RE: Approval of Application for MRP Permit Amendment, Proposed
Ventilation Portal, Convulsion Canyon Mine, ACT/041/002,
#2, #3 and #4, Sevier County, Utah

Re: Proposed Ventilation Portal, Convulsion Canyon Mine,
ACT/041/002, Folder No. 2 and 3, Sevier County, Utah

Title of Proposal: New Ventilation Portal, Quirtchupah Cyn.

LOCATION OF PROPOSED
VENTILATION PORTALS,
SOUTHERN UTAH FUEL COMPANY,
MINE NUMBER ONE IN THE
LITTLE DUNCAN MOUNTAIN
LOCALITY OF
SEVIER COUNTY, UTAH

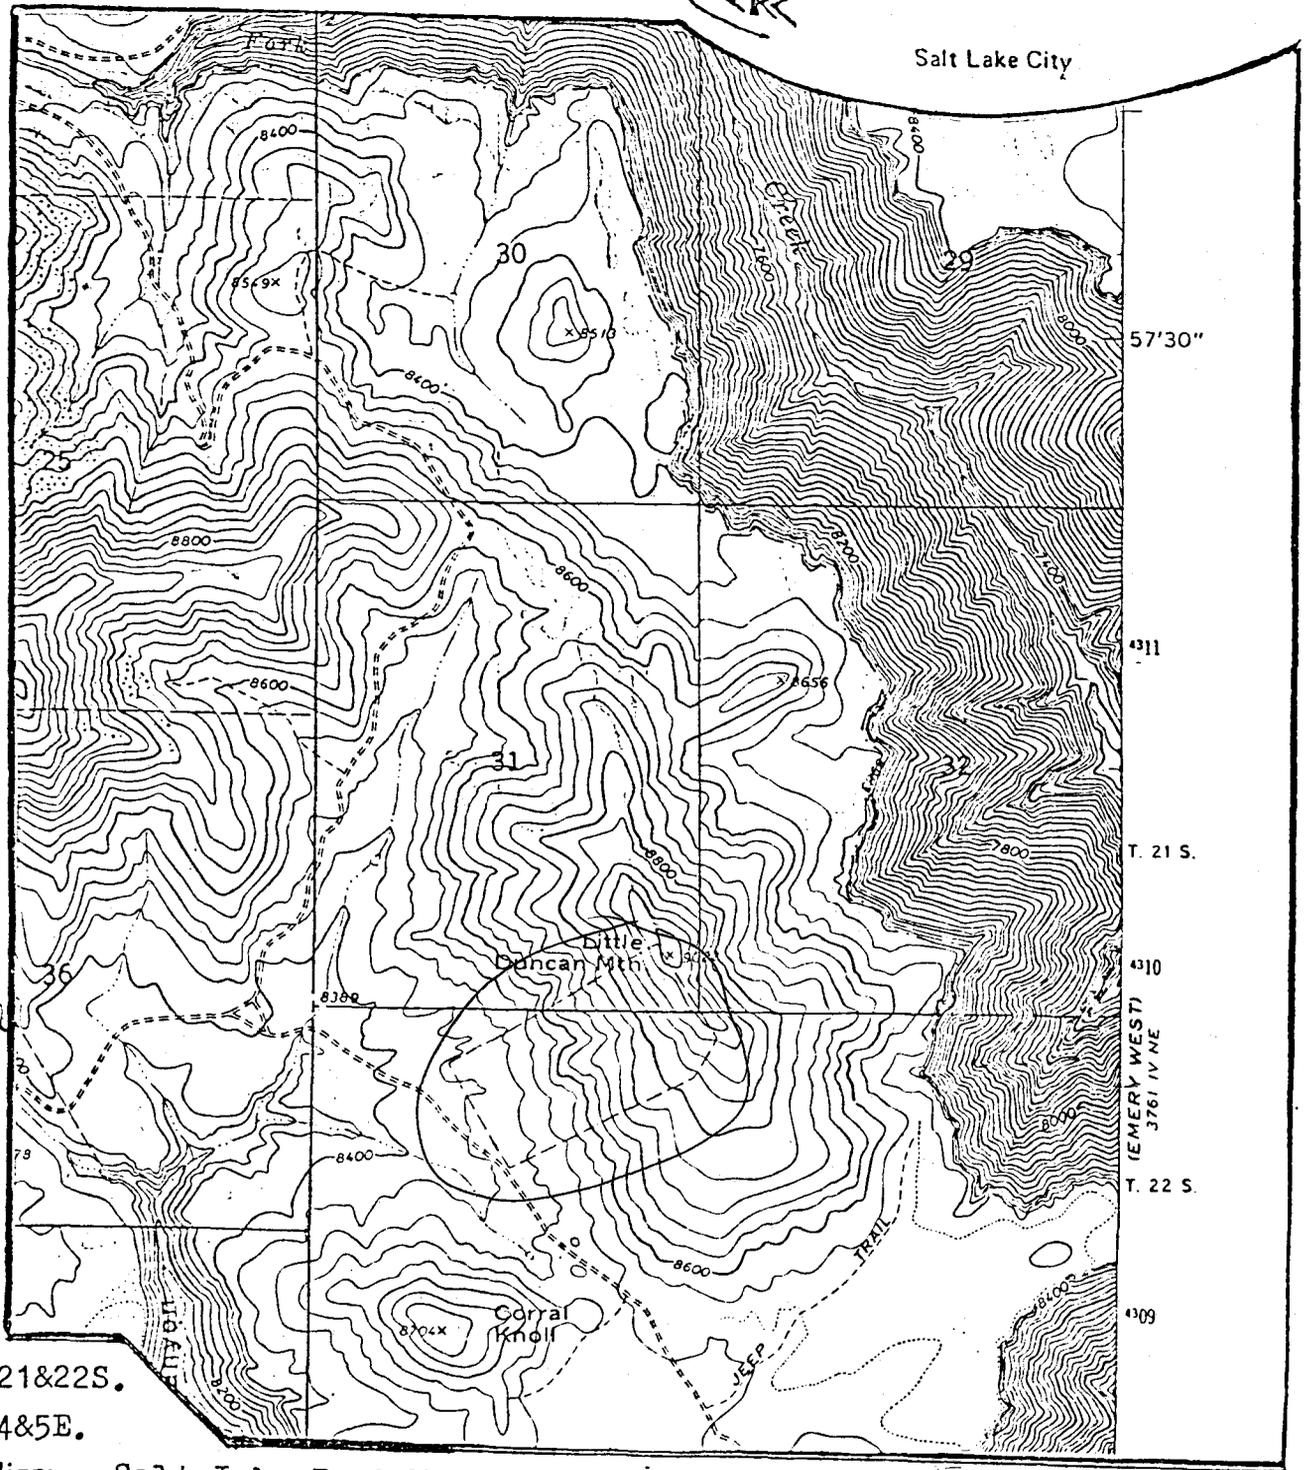
(2-19-85)
I assume
hatched area
is area surveyed
DWH
